SUBJECT: WOLF CREEK GENERATING STATION - ISSUANCE OF AMENDMENT RE:
MODIFICATION OF IMPROVED TECHNICAL SPECIFICATIONS (TAC NO.
MA7792)

AMENDMENT TO FACILITY OPERATING LICENSE

Amendment No. 132
License No. NPF-42

SAFETY EVALUATION BY THE OFFICE OF NUCLEAR REACTOR REGULATION
RELATED TO AMENDMENT NO. 132 TO FACILITY OPERATING LICENSE NO. NPF-42

Figure 3.5.5-1 (page 1 of 1)
Seal Injection Flow Limits

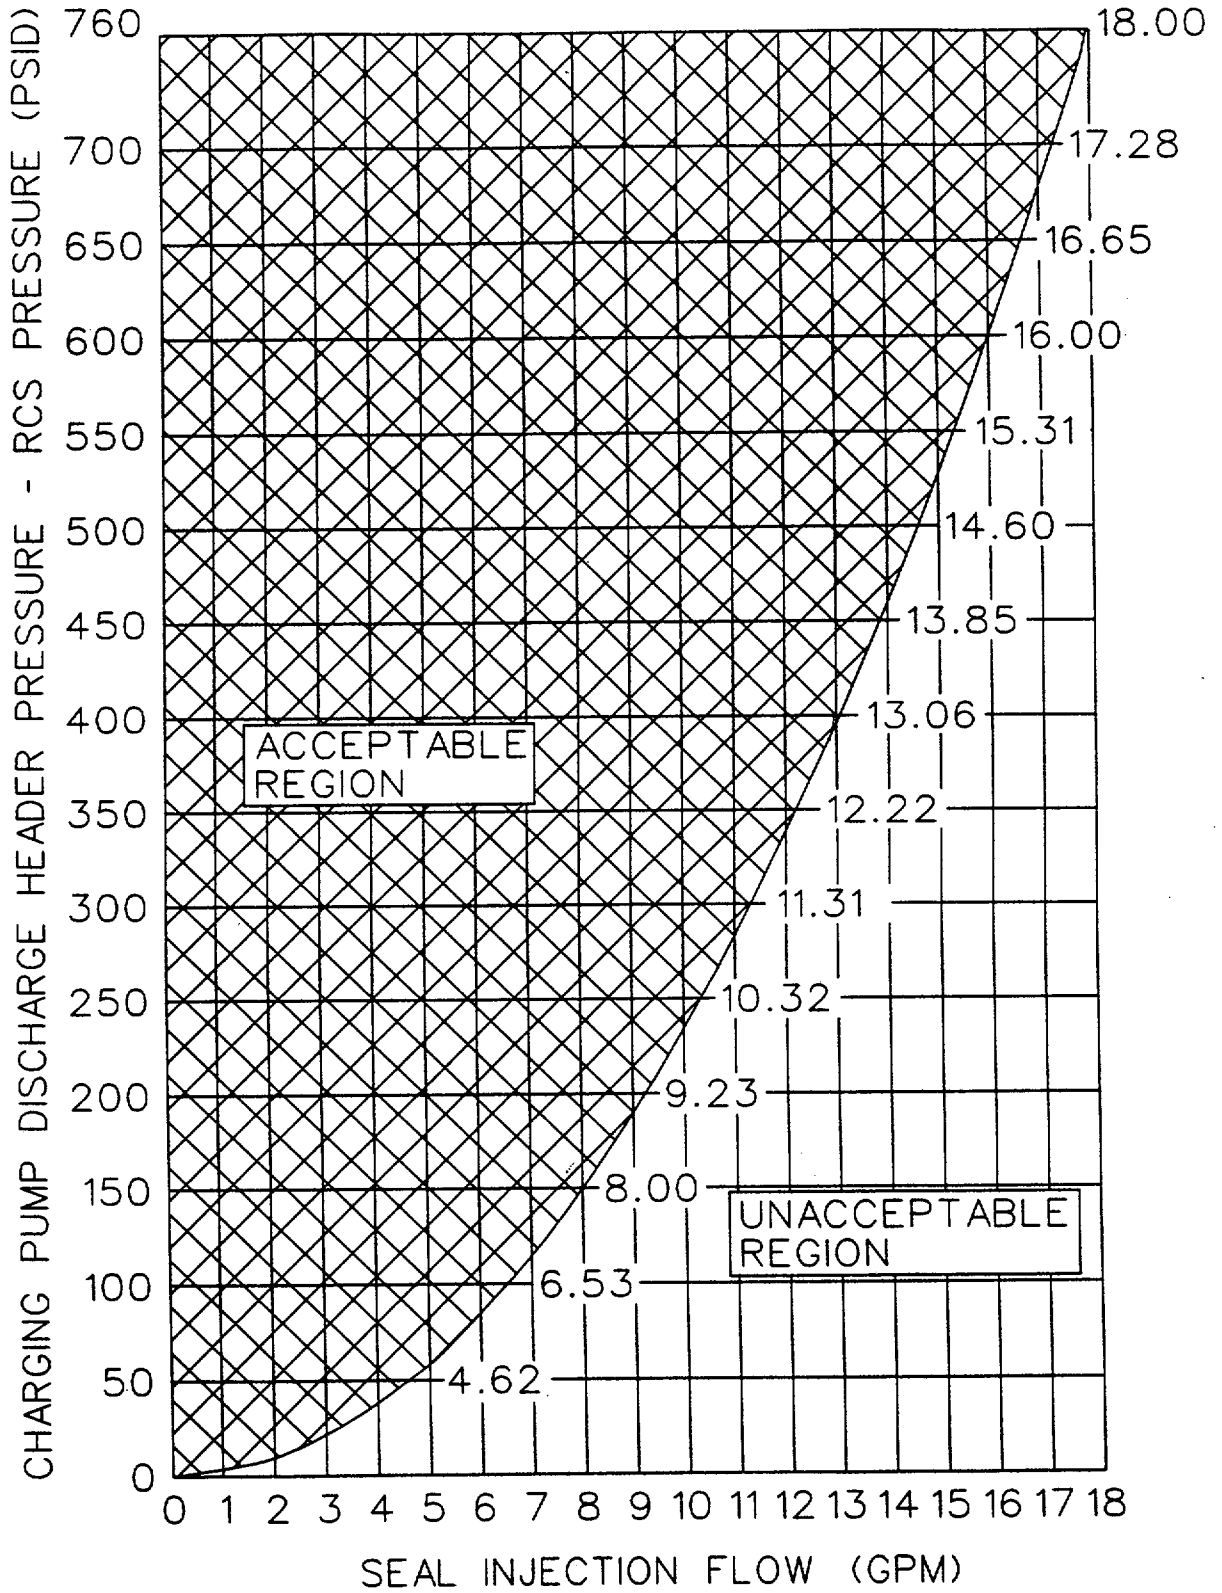
The amendment modifies the improved TSs that were issued in Amendment No. 123 on March 31, 1999, and implemented on December 18, 1999. The changes expand the region of acceptable reactor coolant pump (RCP) seal injection flow to each RCP in Figure 3.5.5-1 and provided 10 editorial changes to the improved TSs.

The proposed changes expand the region of acceptable reactor coolant pump (RCP) seal injection flow to each RCP in Figure 3.5.5-1 and provided the following 10 editorial changes: (1) delete the redundant "%" sign in the allowable value for function 4 in Table 3.3.1-1 on reactor trip system instrumentation, (2) delete the extra spacing in the description of function 20 in Table 3.3.1-1, (3) insert periods at the end of the text for Conditions M and N in the actions for limiting condition for operation (LCO) 3.3.2 on engineered safety features actuation system instrumentation (ESFASI), (4) spell "requirements" correctly in function 5.c of Table 3.3.2-1 for ESFASI, (5) delete the invalid "SR 3.3.2.6" from the surveillance requirements column for Function 7.a in Table 3.3.2-1, (6) align the wording "Coincident with Safety Injection" with the title of Function 7.b in Table 3.3.2-1, (7) align the data in the 4 columns of Table 3.3.7-1, CREVS [control room emergency ventilation system] Actuation Instrumentation, for Function 3 with the first line of the title of the function, (8) align the specified completion time in Condition B of the actions for LCO 3.7.1 for main steam safety valves with text for the Required Action B.2, (9) add the acronym "EES" to Emergency Exhaust System in the table of contents and use the acronym in the upper right-hand-corner of the 4 ITS pages for LCO 3.7.13 on the emergency exhaust system, and (10) uncapitalize the word "Associated" in Condition B of the actions for LCO 3.8.4 on DC sources - operating because it should not be capitalized.

The proposed Figure 3.5.5-1 is based on the safety analysis assumptions to ensure that there is sufficient safety injection flow into the RCS for cooling the core during a LOCA.

The licensee stated that the proposed changes to Figure 3.5.5-1 will extend the bounds of the acceptable range of seal injection flow to encompass the entire range of acceptable seal injection flow. The range of low seal injection flow is extended to zero flow, below the 6.53 gpm in the current figure, even though the normal operating range of seal injection flow is 8 to 13 gpm per RCP. If the flow is less than 6 gpm, procedure OFN BB-005, "RCP Malfunction," will provide the actions needed to restore seal injection flow; however, this low flow rate is not a safety concern because the RCP thermal barriers would provide sufficient cooling to the pump water bearing and shaft seal if there was no seal injection flow.

The upper part of the curve in Figure 3.5.5-1 is also extended to 18 gpm from the 10.33 gpm in the current figure. This is to depict the flow limit at higher differential pressures which potentially could occur at low RCS pressure. The CCP discharge header pressure is essentially constant and a reduction in RCS pressure would result in more seal injection flow than at normal operating pressure for the settings of the seal injection throttle valves. The upper flow limit was expanded to include the flow for the maximum expected differential pressure during a large break LOCA. The upper seal injection flow limit of 18 gpm per RCP remains within the safety analysis assumptions for the large break LOCA.

Because the acceptable seal injection flow limits in the proposed Figure 3.5.5-1 are within the safety analyses for LOCAs at WCGS, including the large break LOCA, the staff concludes that the proposed figure is acceptable.
